NLE and NLV Compressors Angle of Suction Connector Change

Fig. 1 Suction connector with 45° angle

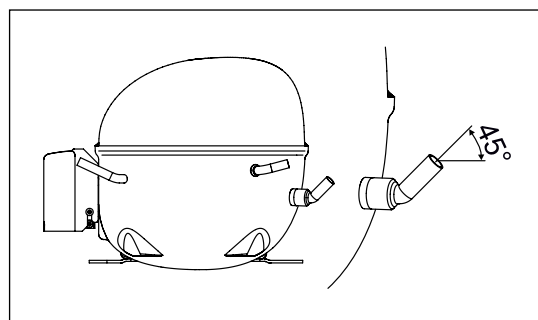
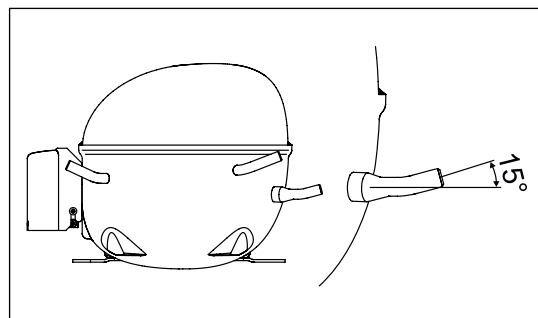
Currently, the angle is 45° (see figure 1). In the future, it will be reduced to 15° (see figure 2). In addition, the connector will be shortened by 3 mm.
